SERVICE UPDATE SEMINAR

2017-2018

KOHLER.
5400 Series
19.5 hp
541 cc
KS595
Rated at 3600 rpm per SAE J1940 Gross
22 1/2 gal.

24 165 01 Recoil Design

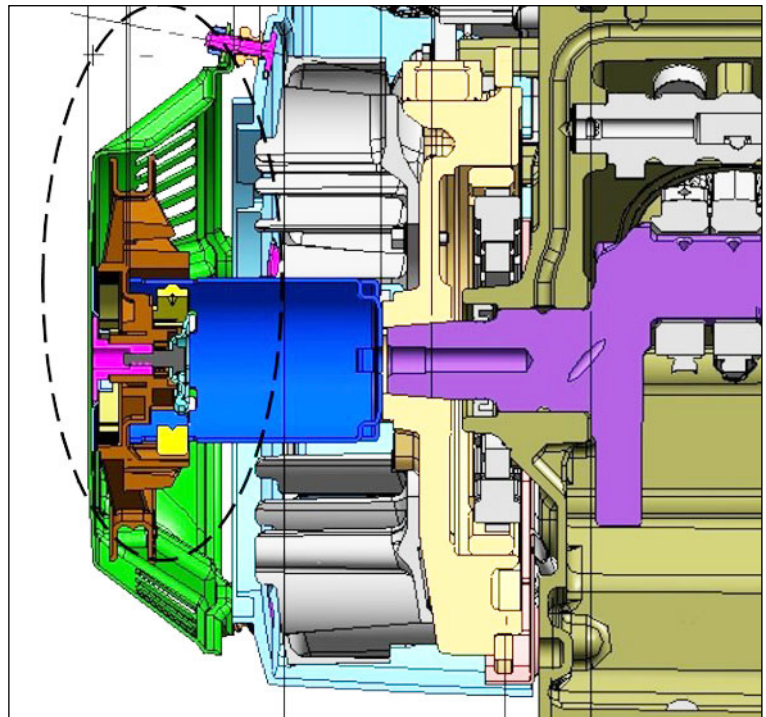
There has been an updated recoil starter released for Command PRO Twins. The new design has stronger, more durable engagement pawls, features a single piece, windowed engagement cup and a recoil pulley made of stronger material.

The previous recoil assembly (24 165 01-S) is superseded in Kohler PLUS to a new kit (24 165 03-S) as the new recoil starter is not compatible with the old engagement cup and requires all the components to be be replaced including a shortened flywheel bolt.

- Addition of Upper Main Bearing Sleeve

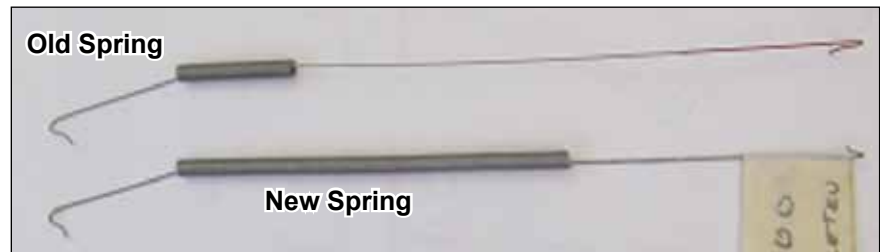
An upper main bearing sleeve has been inserted to the flywheel side of the crankcase for increased durability.

- Updated Governor Linkage Springs for Electronic and Mechanical Governor Controlled Systems

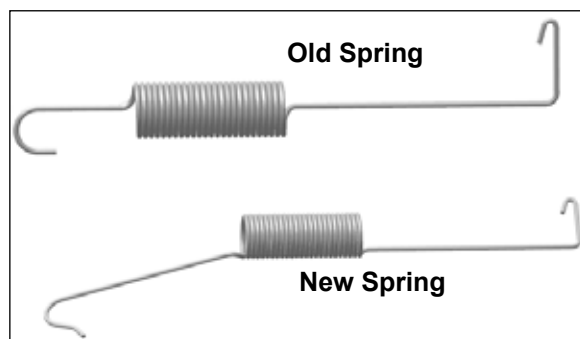
New spring designs have been implemented for both types of governor controls.

Note the longer coil spring body used for mechanical governor systems and the changes in spring arm for the electronic governor linkage spring.

- Changes in Breather Filter Media and Breather Reeds

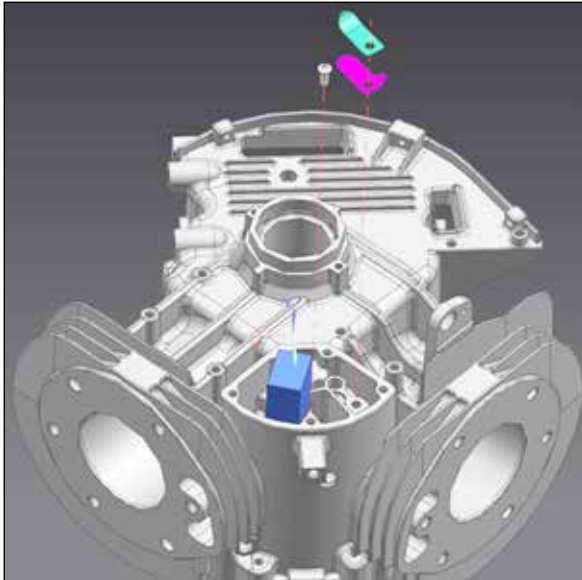
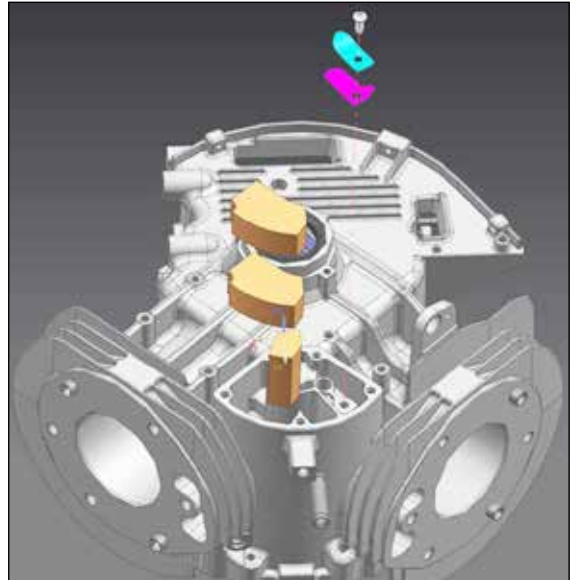
New production units will come with a new breather filter media and different breather reeds. These changes are designed to reduce the amount of oil making it into the intake stream from the breather system.

- 90° Fitting Change

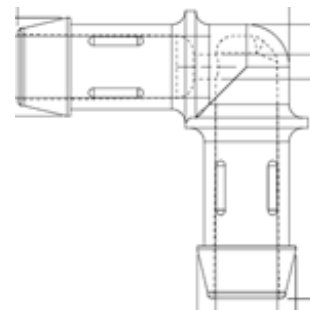
The newly designed fitting that gets placed in the breather tube features a restrictor orifice that is molded into the part. This reduces the amount of vacuum being pulled through the breather system and reduces the amount of the oil being consumed. This part is backwards compatible for all 824 cc engines and is available as a service kit, part number 19 755 17-S. This is to be used in situations where excess oil consumption is observed through both cylinders and the breather system is believed to be suspect.

Positive Retention Dipstick

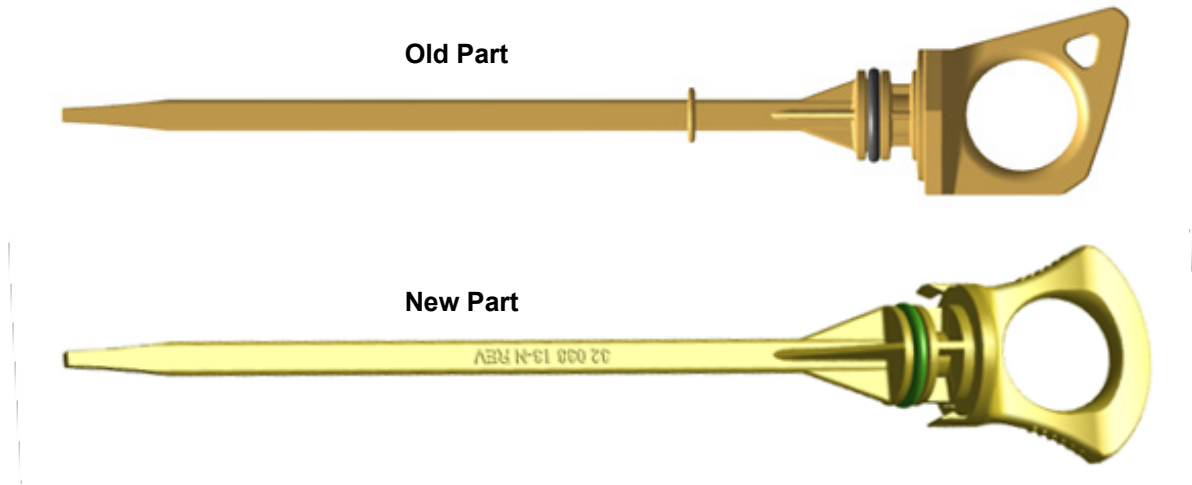
824 cc units in production since December 2016 now utilize a positive retention dipstick similar to what is used on the 7000 Series engines. The new dipsticks must use a matching dipstick tube when used in Service to ensure the retaining tabs engage with the outside diameter of the fill tube.

Figure 2. New Tank 14 065 63-S.

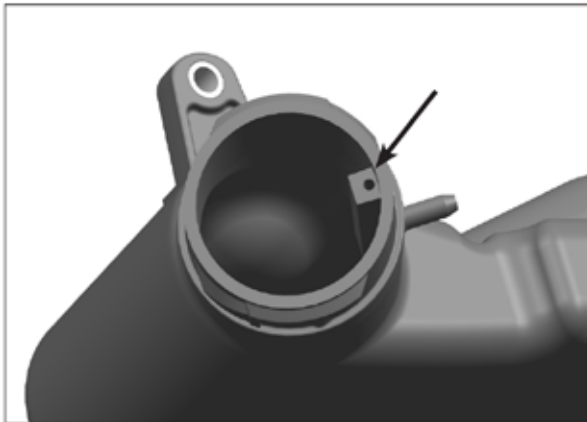
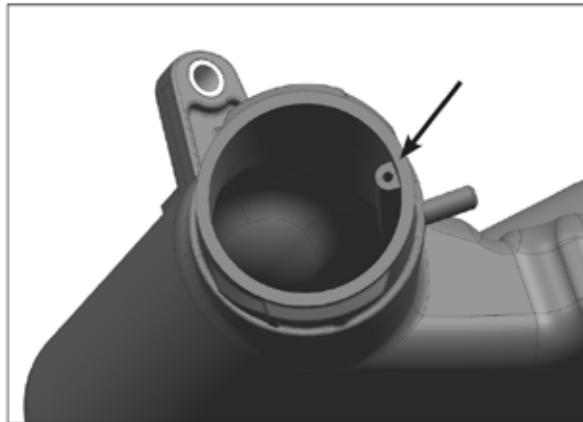
The new 14 065 63-S fuel tank utilizes a material that addresses isolated incidents of nylon leaching into the fuel system (previously covered in the 2013-2014 Service Update Book), as well as improved cap installation and fit.

This new tank should be used as the replacement for any such reports and can be identified visually by the round shape of the internal tank neck feature shown below.

Figure 2. New Tank 14 065 63-S.

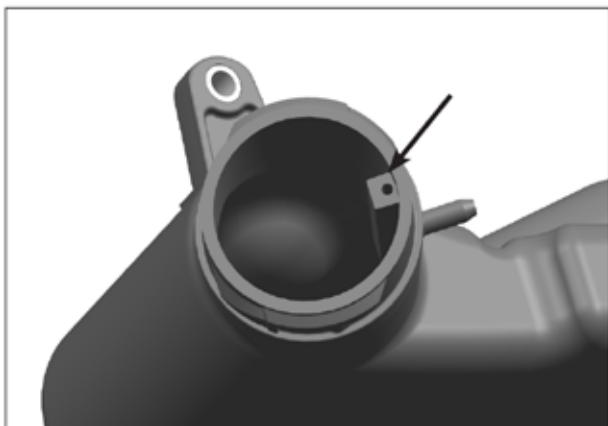
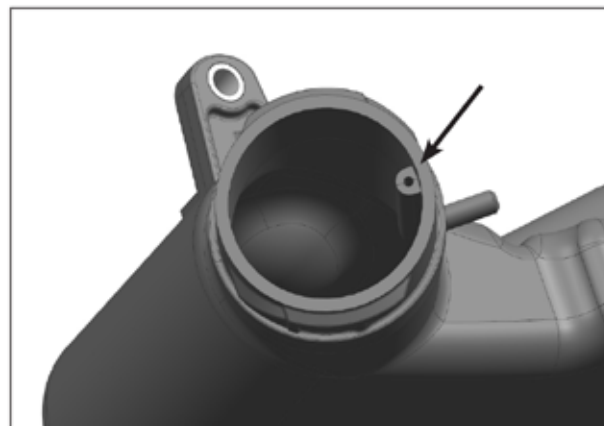
A new 14 065 63-S fuel tank has been implemented with a material that addresses isolated incidents of nylon leaching into the fuel system (previously covered in the 2013-2014 Service Update Book), as well as poor fuel cap installation and fit.

This new tank should be used as the replacement for any such reports and can be identified visually by the round shape of the internal tank neck feature shown below.

Figure 2. New T-Fitting and New Line Assembly.

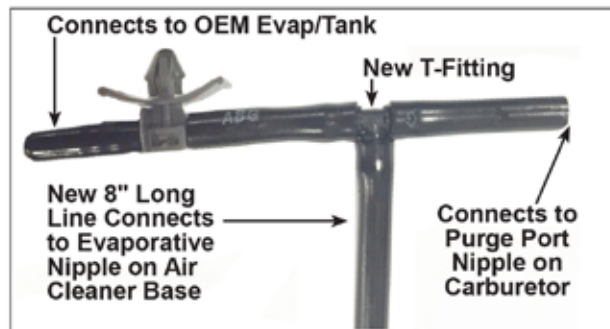
3. Install the new T-Fitting at the location of the cut line. Take the new 25 326 28-S 14" long line and cut it to an 8" length. Install and route the new 8" long line as shown in Figure 2.

Figure 4. Connect New 8" Long Evap Line to Air Cleaner Base.

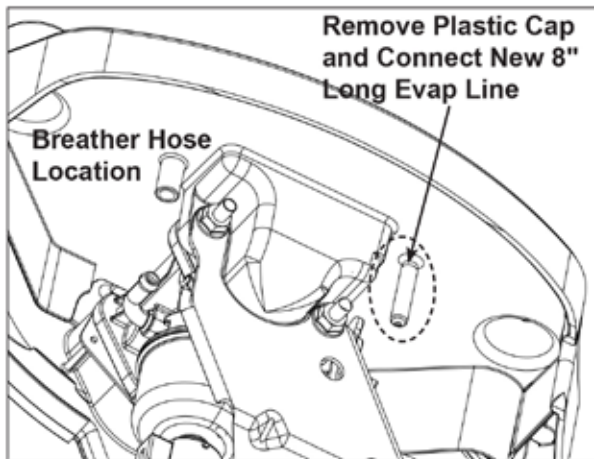
5. Route the new 8" long evap line from the T-Fitting to the plugged port on the air cleaner base. Remove and discard the plastic cap at that location. See Figure 4.

Figure 2. New Governor Linkage Lever and Governor Spring.

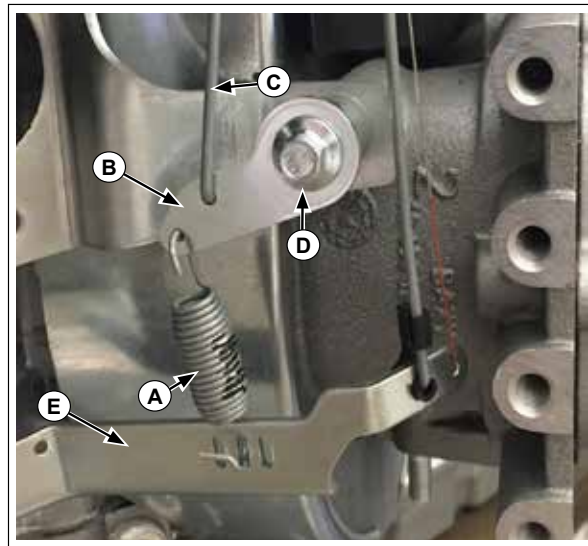
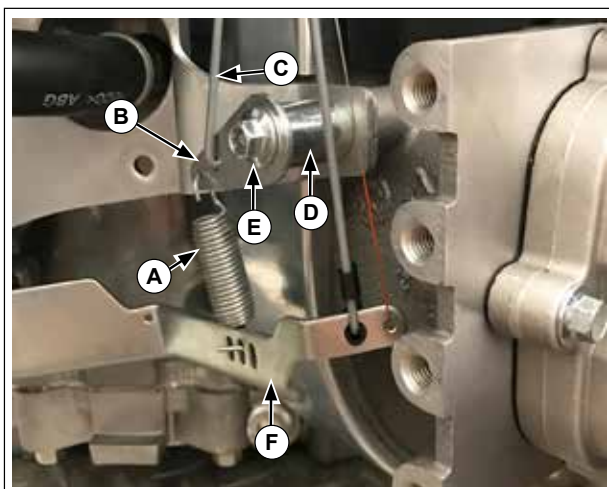
Replacing the original (see Figure 1) black governor spring (19 089 08) with an orange governor spring 19 089 05-S and replacing the original governor linkage lever (19 090 01) with a new design (see Figure 2) governor linkage lever 19 090 05-S that moves the governor spring hole location, should correct this situation.

1. Remove the M6 screw (D) securing the governor linkage lever (B). Unhook the speed control linkage (C) and governor spring (A) from the governor linkage lever (B). Save the screw (D) and spacer behind the governor linkage lever (B); discard the governor linkage lever (B). Remove the governor spring (A) from the governor lever (E); discard the governor spring (A). See Figure 1.

2. Hook the speed control linkage (C) and the new governor spring (A) into the new governor linkage lever (B). See Figure 2.
3. Hook the new governor spring (A) into the middle slot of the governor lever (F). Orient spring ends as shown in Figure 2. Secure the new governor linkage lever (B) and the spacer (D) with the M6 screw (E). Torque screw (E) to 10.2 N·m (90 in. lb.). See Figure 2.
